CITY OF PORTLAND, MAINE
HISTORIC PRESERVATION BOARD

HISTORIC PRESERVATION BOARD AGENDA
November 7, 2018 at 5:00 PM
Room 209, City Hall, 389 Congress Street

**WORKSHOP
10 MELLEN STREET**

TO: Chair Sheridan and Members of the Historic Preservation Board
FROM: Rob Wiener, Preservation Compliance Coordinator
DATE: November 2, 2018
RE: November 7, 2018 **WORKSHOP** – Comprehensive exterior rehab, rooftop decks, rear entry mudroom

Rear porch/entrance reconstruction

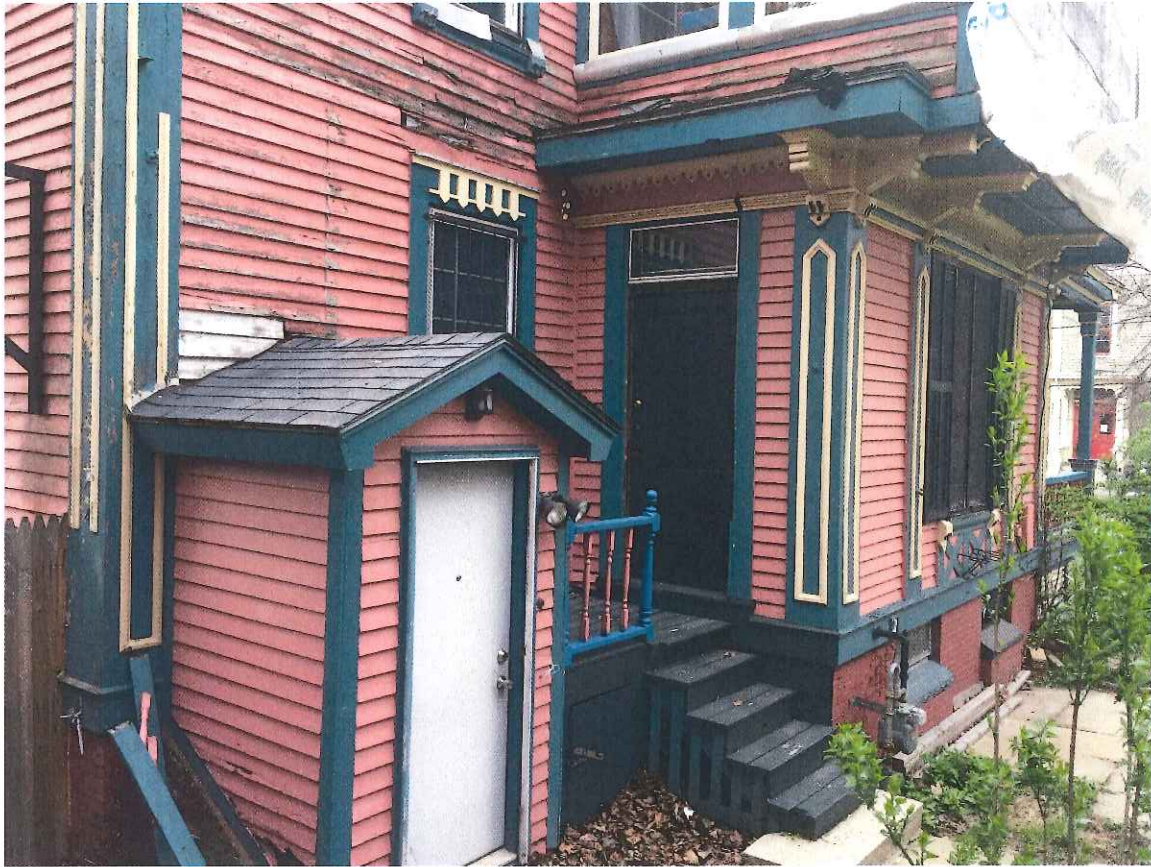
Redesign of the back porch involves three principal changes and encroaches on the property line setbacks (by a few more inches than current).

- Change current west facing back door to a double hung window.
- Change current front, south facing double hung window just west of the present back door to become the new back door, reusing the original back door and transom in its new location.
- Create a common entry porch for both the downstairs apartment and the main house. Contemporary solutions are being considered.
- Extend the entrance of the downstairs apartment southward by 2'2" to allow for a stair landing just beyond the entry for stairs, which cannot be moved back due to headroom limitations where the stairs pass through the south exterior wall.
- The rear porch roof will match the dimensions and exact style of the front porch roof, including parapet, as shown in the 1924 tax photo. It will have the same height and visual weight as the matching front porch in proportion and upper detail, in effect creating a mirror image.

Proposed window change including parapet reconstruction

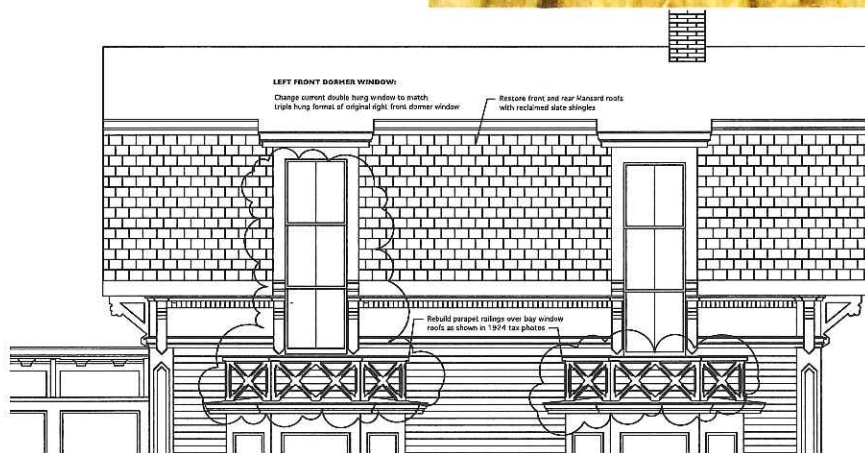
Mr. Gorman and Ms. Willens propose to change the south (left hand, as viewed from the street) front dormer window match the taller triple-hung window in the north dormer. The exact history of these windows is uncertain, and the original window plans are unknown. We know several things from the photographic evidence:

- Both the triple-hung window to the north and the double-hung window to the south are quite old – the tax photo appears to show the windows as they currently exist.

- It is possible that the north window was altered in an early (pre-1924) renovation to add light to the third floor and create access to a small, street-facing balcony on top of the bay.

- Though they existed in 1924, it is not known whether the “X” motif balustrades atop the front bays are original, but it seems likely they were added when the north dormer window was lengthened to a triple-hung window. The “X” motif appears in the frieze and decorative trim, but these balustrades do not match the more standard balustrades on the porches, which have vertical balusters.

DECK FRAMING PLAN

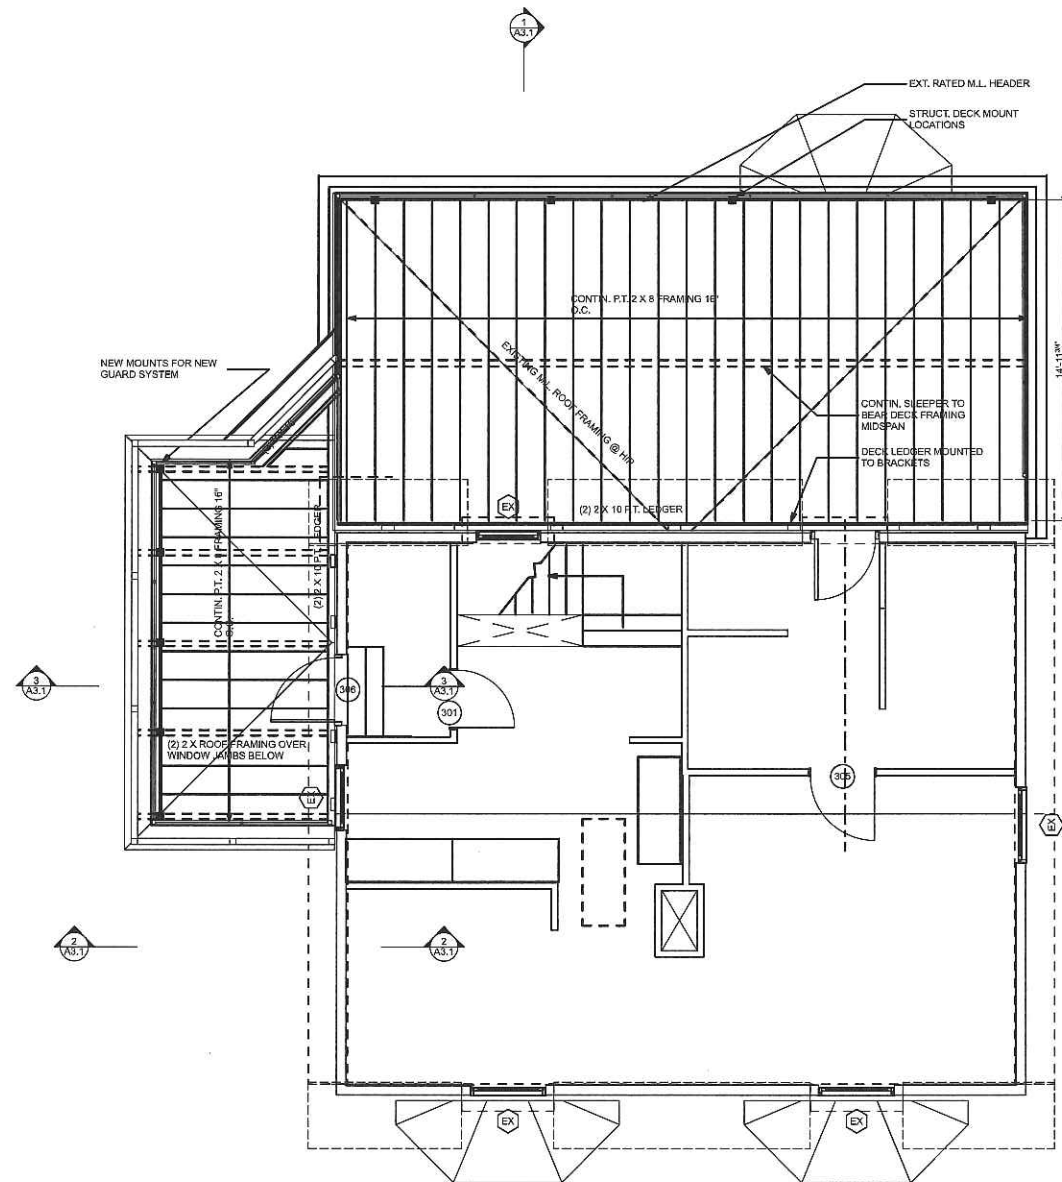
The rooftop deck proposed above the south sunporch is perhaps the most visible of the additions in question. In previous conversations with Mr. Gorman and Mr. Delaney, staff advised keeping decks well back from roof edges to lessen visibility. Additional staff notes on the decks:

- Restoring the original third floor window on the south side will be a positive step in recreating the original appearance.
- The most recent elevations by Tony Taylor show a welded steel railing, but no deck framing. The earlier conceptual drawings by Joe Delaney showed deck framing above the roof. Staff emphasizes that the Delaney elevations probably more accurately depict the height of the deck structure above the sunporch roof, and the Tony Taylor elevation does not represent the full visual impact of a third floor deck atop the sunporch.

- It appears that the rear rooftop deck may be slightly higher (one step) than the sunroom deck, according to the Delaney plans, though not depicted that way on the Tony Taylor elevations.

Staff believes construction details on the third floor deck above the sun porch will be important in assessing whether the addition of decks – particularly above the sunporch - will be an acceptable change to the house. Critical factors will be the height of the deck structural framing, height and appearance of railings, and overall size and proximity to the edges of the roof.
